Comet Ridge Limited

**DCCEEW IESC Advice Response
Mahalo North PL 1128**

EPBC 2023/09689

Figure 1: Existing Monitoring Locations and Proposed Nested Piezometer Locations

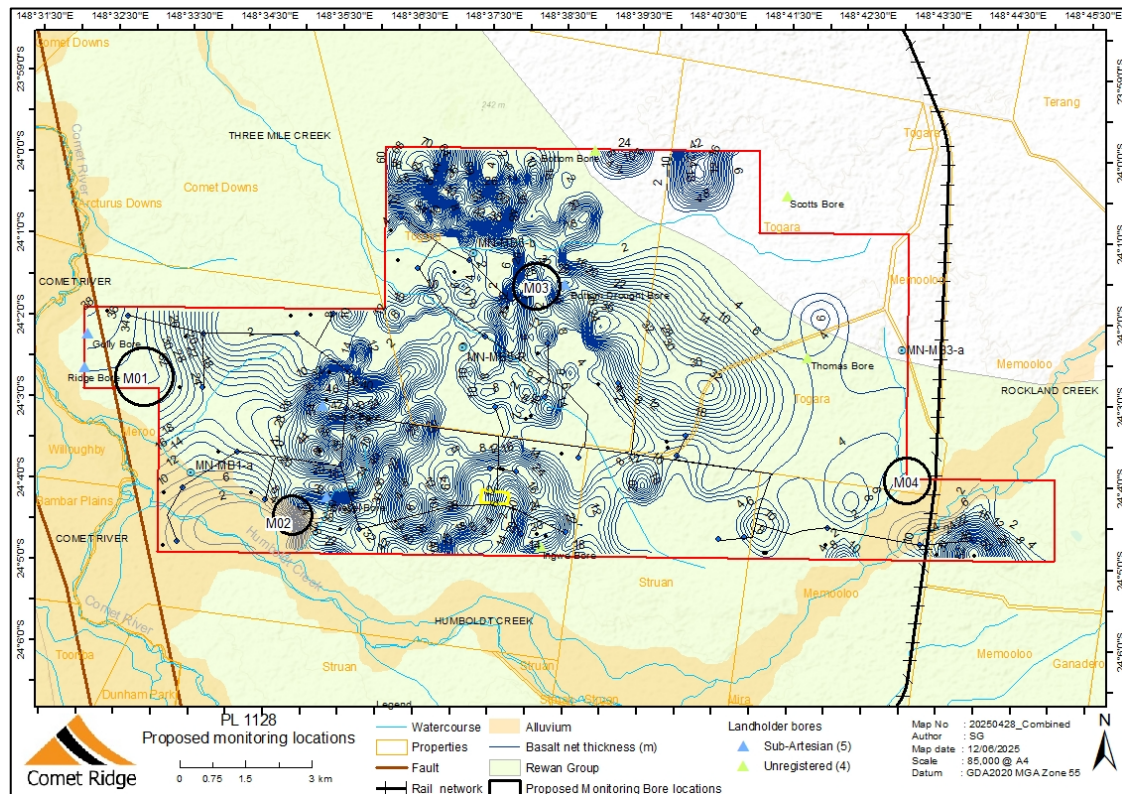
5. *The information in the project documentation is insufficient to support the hydrogeological conceptualisation, so the reliability of the modelled results and the conclusions cannot yet be determined. The critical issue is the proponent's assertion that there is no hydraulic connection between the coals and the Tertiary aquifer, which determines whether groundwater drawdown can propagate to the surface. Although the Rewan Formation and coal interburden are likely to have very low vertical hydraulic conductivity, this needs to be measured. The baseline data do not convincingly demonstrate the large differences in potentiometric heads between the deeper and upper aquifers that would indicate little or no connectivity, particularly where the coal measures subcrop beneath the Tertiary aquifer.*

The WMMP 2025 in section 8.5 summarise the additional investigation proposed to assess the aquifers interconnectivity. This investigation includes the installation of four (4) nested piezometer clusters (M1 to M4) designed to monitor key hydrostratigraphic units:

The nested bore design supports direct assessment of vertical hydraulic gradients, head differentials, and connectivity risks. The locations are shown in **Figure 1** and were selected to reduce conceptual uncertainty in geologically sensitive areas, as follows:

1. M1 – Western Fault Zone (Arcturus Fault)
Installed proximal to the Arcturus Fault, a major structural feature that may compromise the integrity of the Rewan aquitard. This cluster is intended to assess the

potential for fault-assisted vertical hydraulic connectivity between the Bandanna coals and shallower aquifers.

2. M2 – Southern Reference Site

Located in the southern section of the PL, where sedimentary facies transitions within the Rewan Formation may influence vertical permeability. This site provides a comparative baseline to evaluate natural stratigraphic separation in the absence of structural complexity.

3. M3 – Subcrop Transition Zone

Positioned where the Rewan Formation subcrops beneath the Tertiary strata, offering a direct opportunity to assess vertical gradients and evaluate the integrity of the aquitard system where protective layering is potentially thin or absent.

4. M4 – Alluvial Interface Zone

Situated in the southeast, near low-lying alluvial channels and the Bandanna hydraulic axis, this cluster will support assessment of lateral connectivity between deep aquifers and alluvium potentially connected to surface water systems.

Figure 2: Geological Cross-Section from Southwest to Northeast (Down-dip)

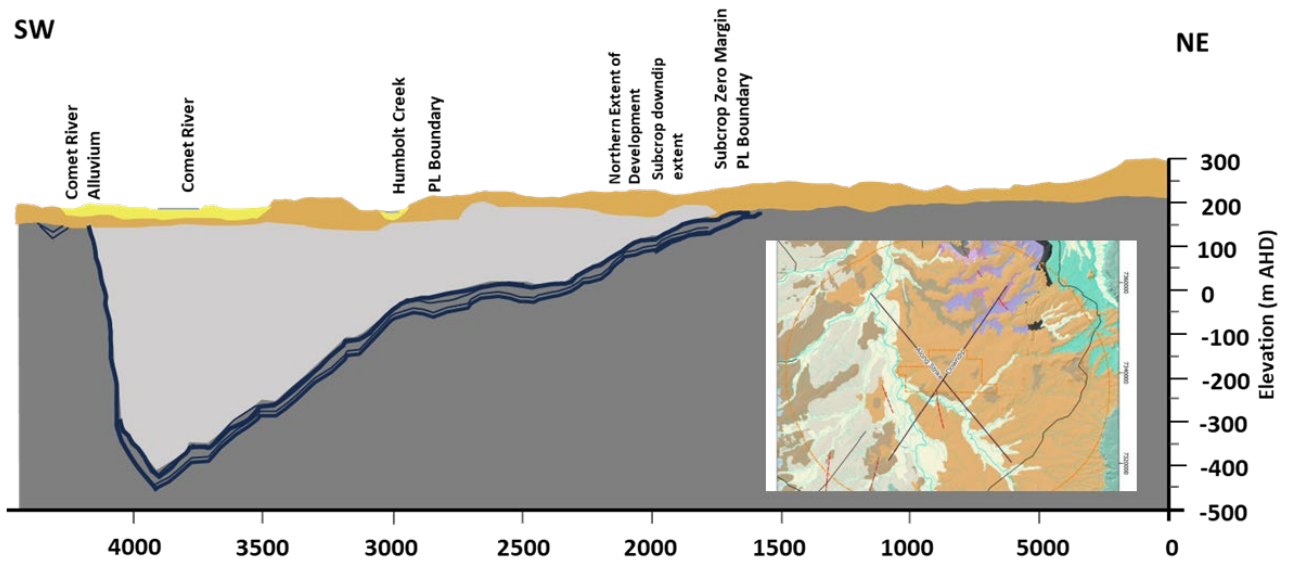
8. *The stratigraphic and hydrostratigraphic conceptualisation presented is a combination of the Queensland Office of Groundwater Impact Assessment (OGIA)'s Underground Water Impact Report (UWIR) regional model and the Comet Ridge geological model, which was not provided (RDM Hydro 2024a, pp. 29). Further information on the Comet Ridge geological model (the static reservoir model) should be provided, including cross-sections and maps showing the data used to develop it, so that the reliability can be assessed spatially.*

The Comet Ridge geological model is comprised of proprietary data and is commercial in confidence. The geological model was built from nearly 1,000 exploration boreholes drilled on an approximately 1km x 1km grid. Two cross-sections from the geological model are presented in the Groundwater Impact Assessment Report (RDM Hydro, 2024, pp 29).

Figure 2 shows a geological cross-section from the geological model in a down-dip profile. The section identifies the subcrop of the Rewan Formation at the eastern edge of the PL as well as the thickness of the Rewan across the entire PLA. The Rewan is approximately 25 m thick at the subcrop and increases to approximately 200 m thick across the development area of the PL. At the northern extent of CSG development The Rewan Formation is approximately 100 m thick.

The model will be updated with the results of the connectivity investigations outlined in the RCP 2025 prepared by Terra Sana Consultants (2025a) to validate the existing Comet Ridge geological model and increase the understanding of the extent and thickness of the Rewan from the subcrop to the western boundary of the PL.
